City of Bellevue
Development Services Department
Land Use Staff Report

Proposal Name:	Yarrow Creek Stream Channel Restoration
Proposal Address:	**3265 103rd Place NE (Generally)**
Proposal Description:	Land Use approval of retroactive application for Critical Areas Land Use Permit to correct damage caused by City of Bellevue Utilities Operations and Maintenance work. The project includes the restoration of the channel of Yarrow Creek directly adjacent to SR 520 upsteam of an abandoned section of Lake Washington Boulevard NE. The restoration activity was completed as an emergency action allowed under LUC 20.25H.055.B, LUC 20.25H.055.C.3.b, and WAC 197-11-880. The restoration includes the placement of wood and rock within the stream channel and the replanting of the streambank riparian area.
File Number:	**09-104532-LO**
Applicant:	**Don McQuilliams, City of Bellevue Utilities**
Decisions Included:	Critical Areas Land Use Permit (Process II. LUC 20.30P)
Planner:	David Pyle, Planner

YARROW CREEK TRIBUTARY
LOG PLACEMENT & REVEGETATION PLAN
PREPARED FOR: PETE BLANE
CITY OF BELLEVUE UTILITIES DIVISION
2901 115TH AVE NE
BELLEVUE, WA 98004

EXISTING CONDITIONS

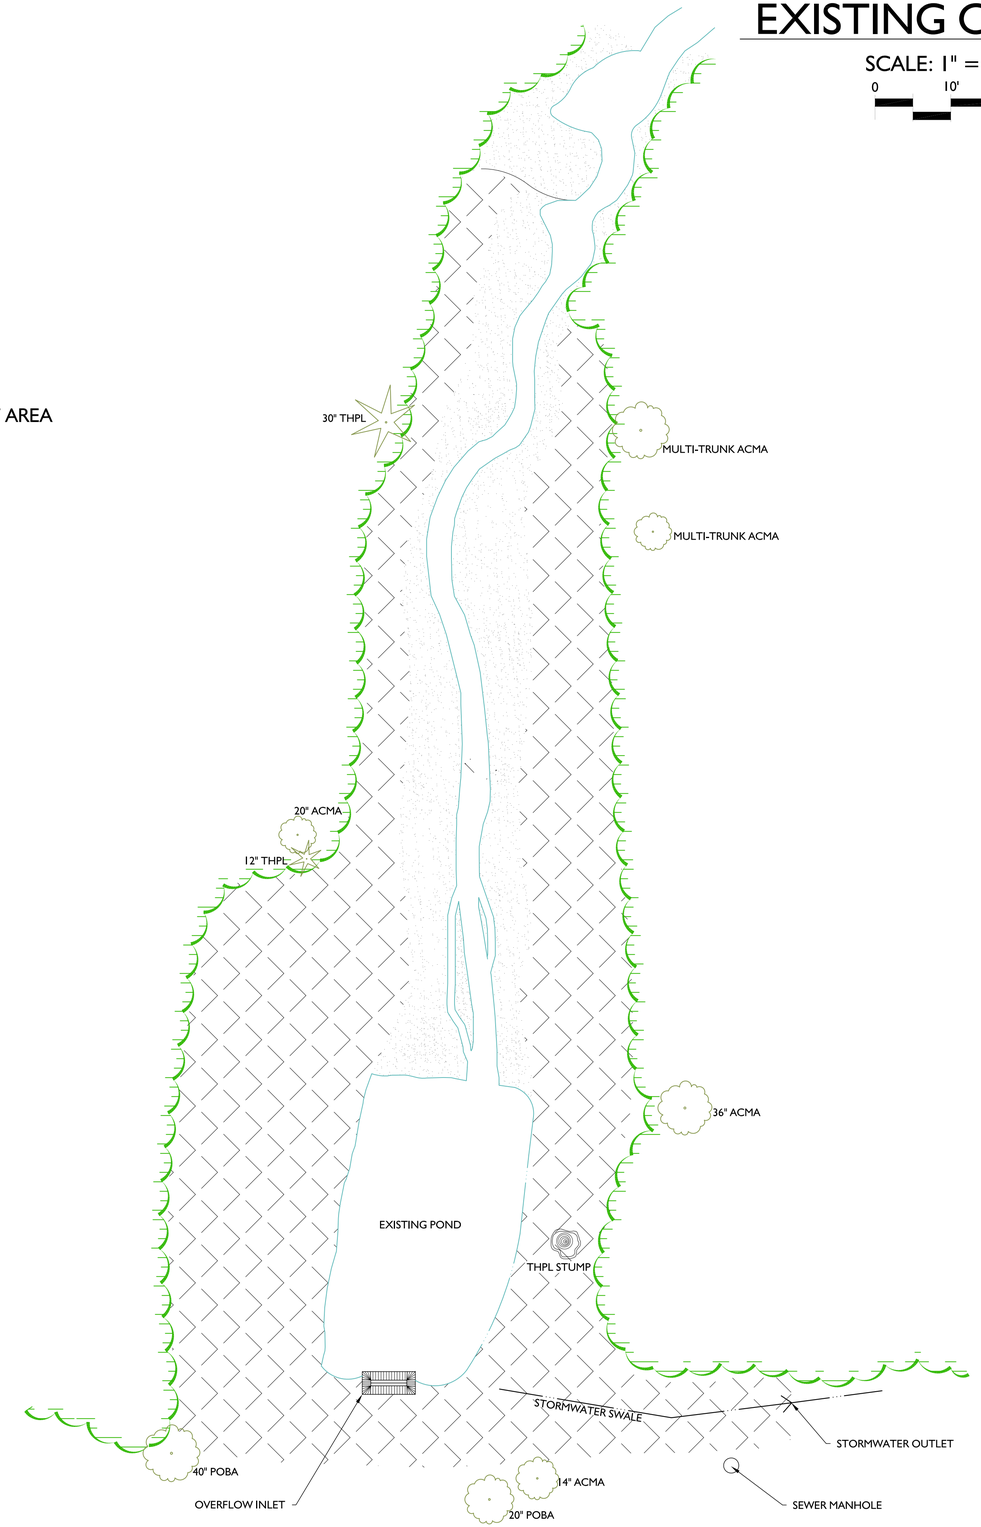
3. Sheet 1 of 5 shows an overflow inlet at the trash rack at the end of the existing pond. Is there a high flow by-pass system on this stream? If so, please describe.

3. Sheet 1 of 5 shows an overflow inlet at the trash rack at the end of the existing pond. Is there a high flow by-pass system on this stream? If so, please describe. There is not a high flow bypass at this location and there is no plans to install a structure of this type. The existing inlet is approximately 3-5 feet above the bottom of the settling pond.
